Town of Arlington, MA Redevelopment Board

Agenda & Meeting Notice June 26, 2017

RE: 483-489 Summer Street Redevelopment – Stormwater Mitigation and Site Plan Review

To: Arlington Redevelopment Board
From: Jennifer Raitt, Secretary Ex-Officio
Subject: Environmental Design Review (EDR), Docket #3522, 483 Summer Street
Date: January 9, 2017, Revised 6/26/17

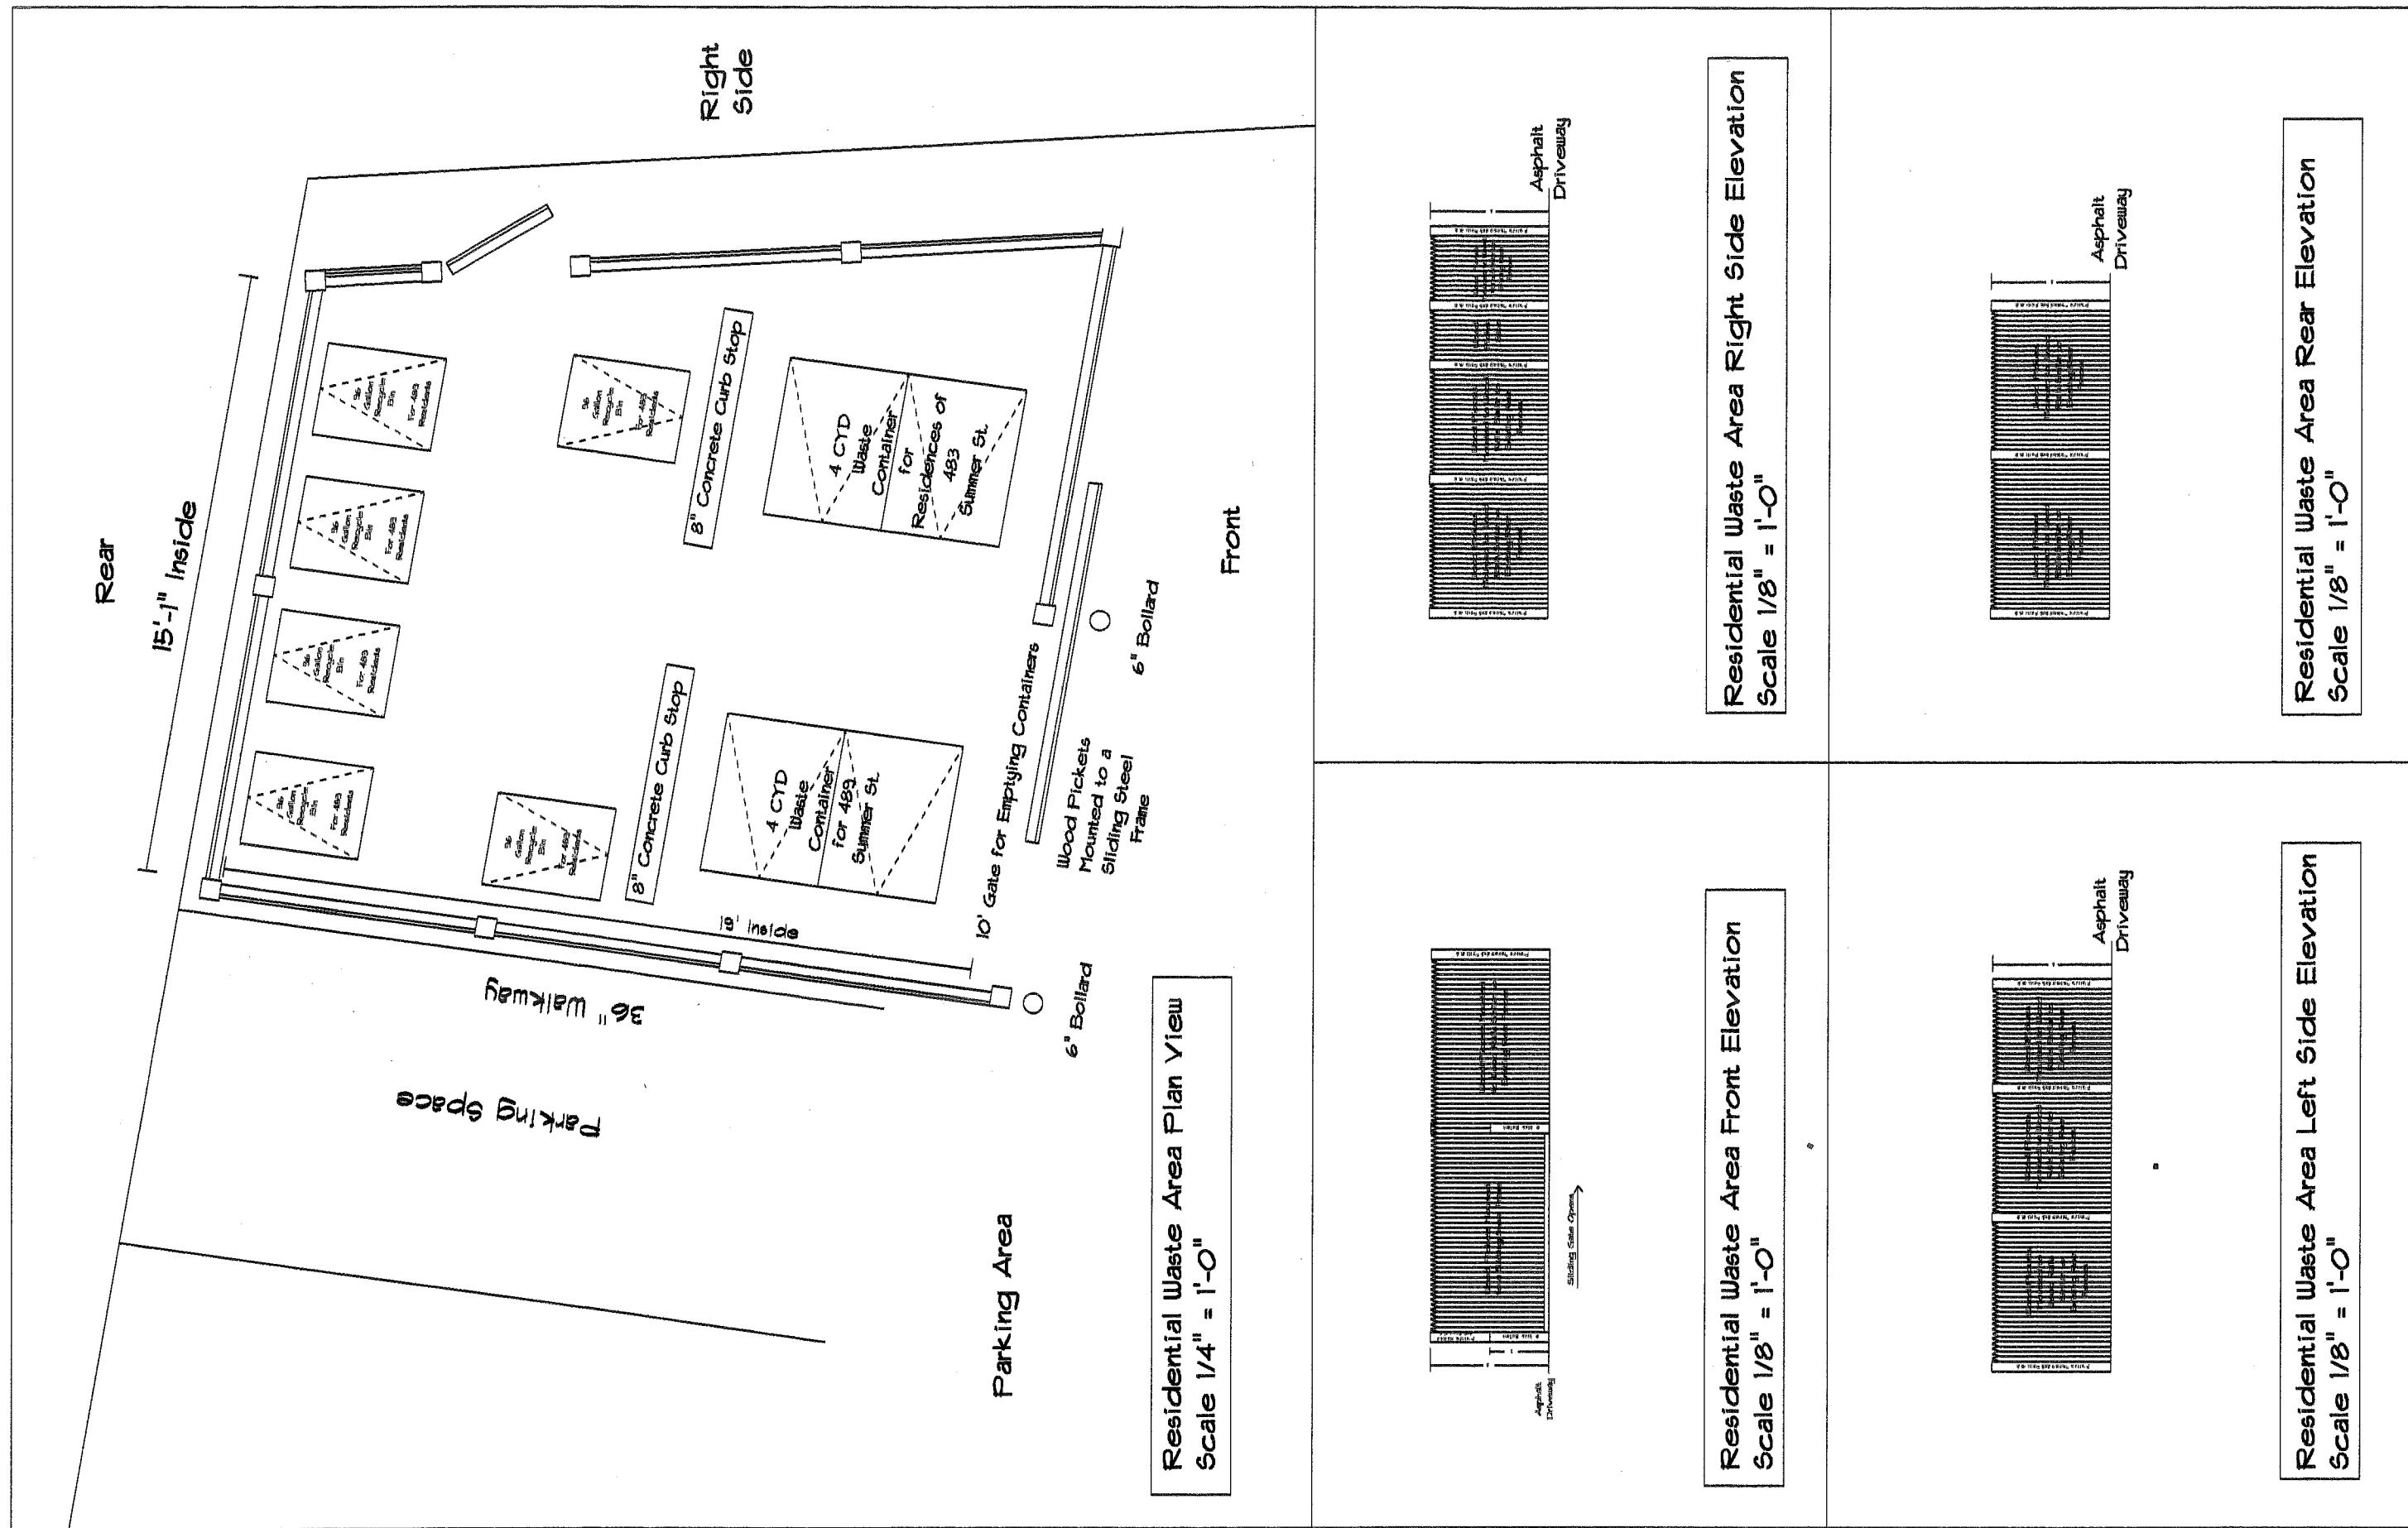
The model scenario presented in the Report appears to analyze a single design point to which stormwater flow will travel for both the predevelopment and postdevelopment scenarios. This design point is not clearly identified in the Report or on the Plans. Further, based on the Engineering Division's understanding of the collective site conditions at both 483 and 489 Summer Street, the use of a single design point is insufficient for analysis. Based on the topography of the site, observations of the Engineering Division during wet-weather events, and the discussion held between the Engineering Division and representatives of A.R. Ronayne & Sons, LLC, on May 19, 2017, the Engineering Division recommends that additional modeling scenarios be completed for the site, and that at a minimum the following three design points should be analyzed to verify that stormwater flow from the corresponding subcatchments will not increase:

1. Eastern Corner of 483 Summer Street: Stormwater is known to flow to this corner of the site under existing conditions and it is also the outlet location for the proposed raingarden.
2. Southern Corner of 483 Summer Street: The existing topography indicates stormwater currently flows to Summer Street under existing conditions in the vicinity of this location.

3. Eastern Corner of 489 Summer Street: Under existing conditions, stormwater from the surrounding parking lot and landscaped areas is known to flow towards this corner and off-site to an existing clogged catchbasin or to the abutting condominium complex.

In addition to the Report comments presented above, it is noted that the following items that were discussed at the aforementioned May 19th meeting are not present on the proposed Site Plans:

1. Dry Wells at 489 Summer Street: Roof leaders from 489 Summer Street would be directed to new dry wells to account for increased impervious area related to site paving for additional parking spaces.
2. Berm in the eastern corner of 489 Summer Street: A berm in this corner and additional grading work would redirect flows from the parking lot at 489 Summer Street to the proposed rain garden at 483 Summer Street.

These items were discussed as possible methods to mitigate any increases in stormwater flows from the site (should there be any), particularly flows directed towards the eastern corner of 489 Summer Street. While these items are not required, they are noted once again as methods which may provide a reduction in overall stormwater flows from the site to any design point should the updated modeling scenarios indicate further site work is required.

In regards to the proposed rain garden, it is noted that a single emergency outlet has been presented at the eastern corner of 483 Summer Street. As this would deliver any overflows from the rain garden to abutting properties in a concentrated flow stream, it is recommended that a level spreader be used to handle overflows rather than the single outlet. This would reduce the impact of a concentrated runoff from the rain garden.
